ANGEL PLACE
LEVEL 8, 123 PITT STREET
SYDNEY NSW 2000

26 April 2019

CHATSWOOD CHASE DA 2017/503 - SNPP REQUEST FOR INFORMATION

APPENDIX A – AMENDED DESIGN REPORT & PLANS

Drawing Title
Havilah St - Elevation 05

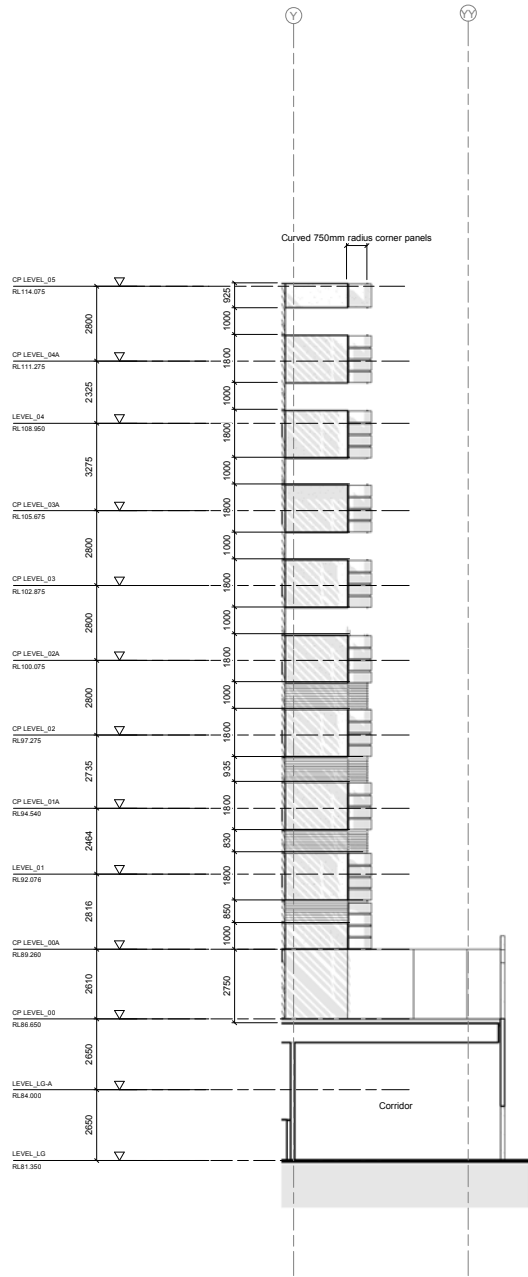
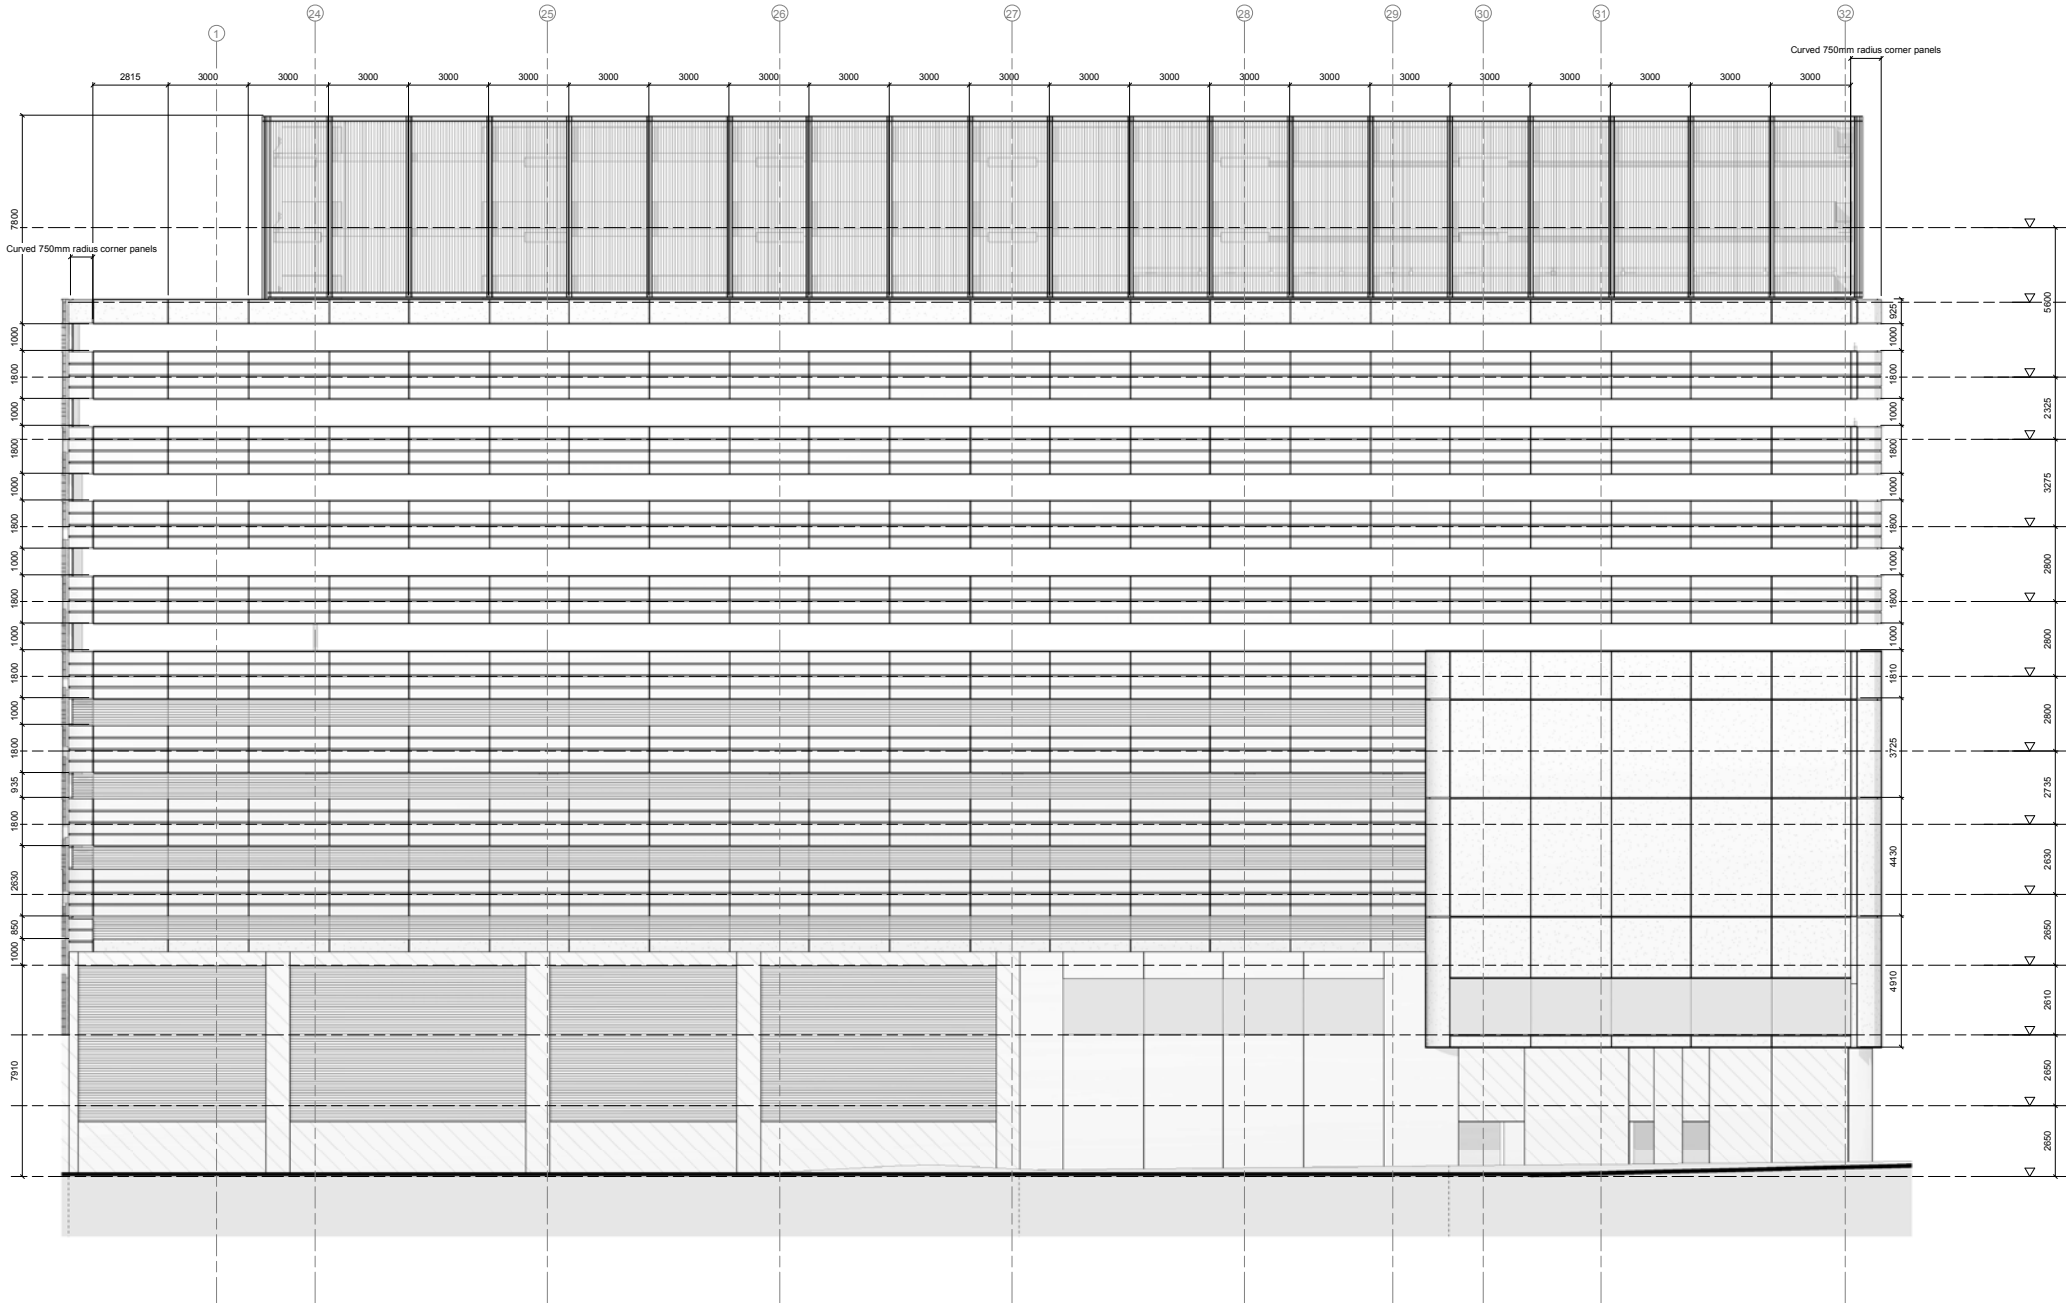
- Amended plans by Make Architects at **Appendix A** which illustrate:
 - Changes to design treatment to the façade on Havilah Street including additional greening at the upper level to reflect the positive treatment for the carpark façade, and

- Introduction of photovoltaic cells in both vertical recessed entrances and held by landscape to upper horizontal band
- Introduction of a green veil to the upper levels, providing specialised growing vessels and media to ensure sustained and robust growth to suitable climbing species upon a mesh that extends to multiple levels.

- The green veil provides softening to the facade, connecting the green from rooftop to street-scape, reducing heat island effect by greening the hard scape and a more sensitive outlook for neighbouring residents.

- Enhance greenery to car parking
- Identification of pavilion and functions through materiality change between car parking and retail
- Darker tone to car park pavilion

Project
Chatswood Chase
Drawing Title
External Wall Systems 31 -
Carpark Level 05-06
Photovoltaics
Scale at A0
1 : 20
Date
DD/MM/YY
Project No.
1506
Rev No.
00
Drawing No.

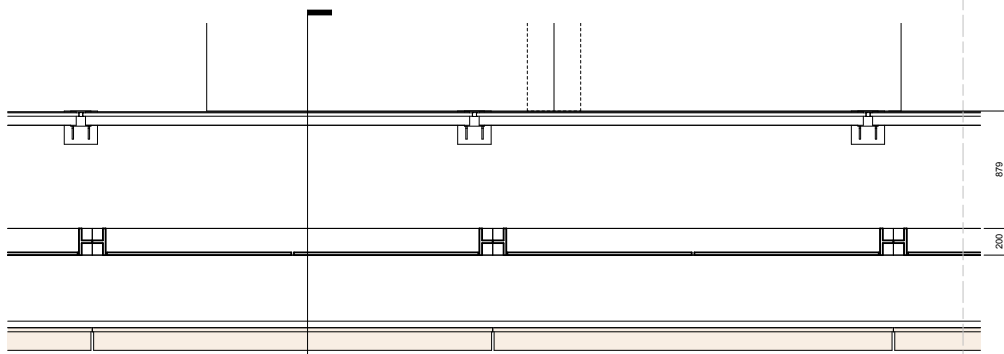
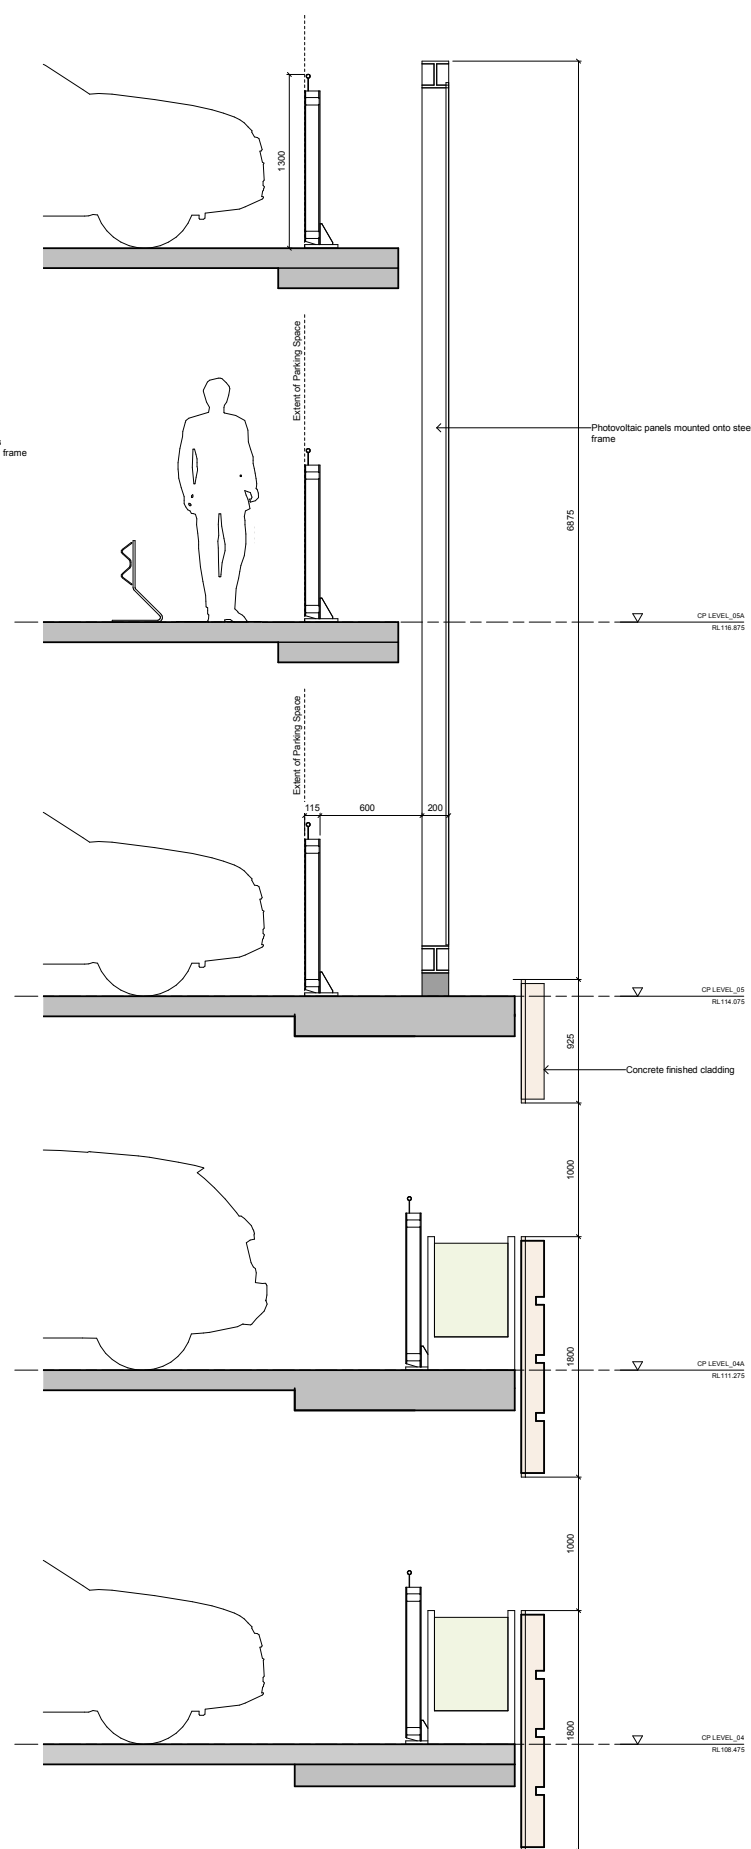
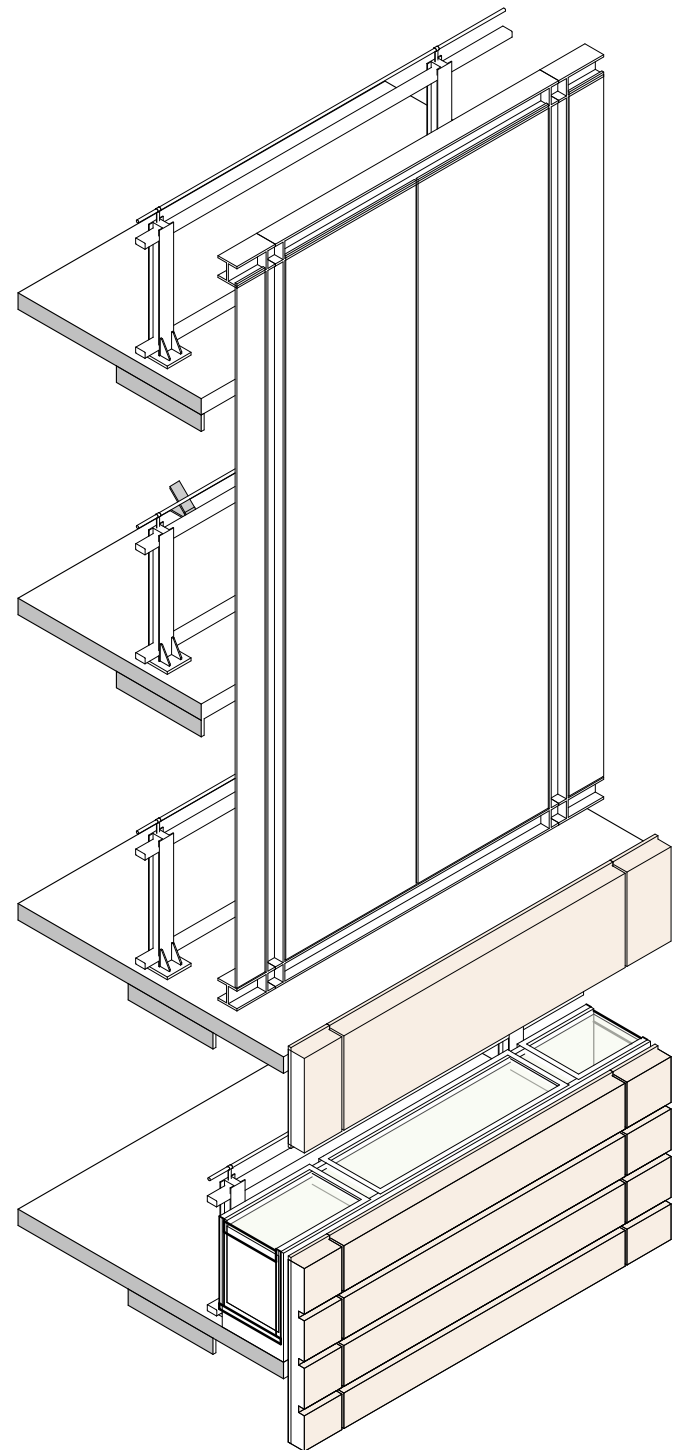
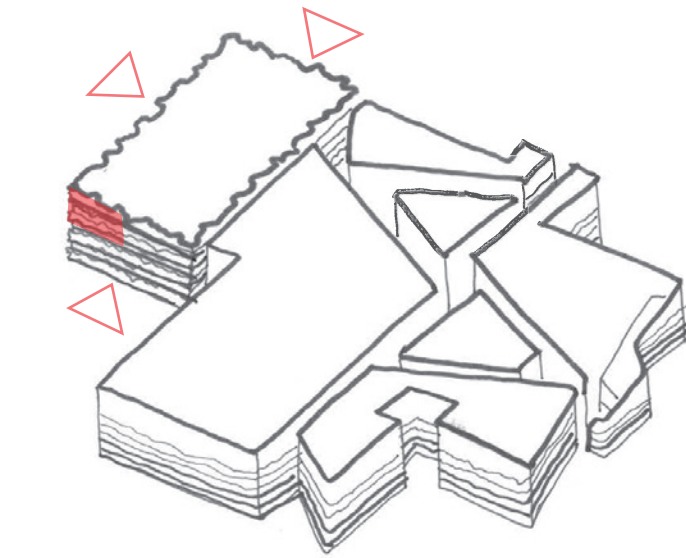
PV location is fixed by the requirements of the car parking and structural requirements for slab edge design.
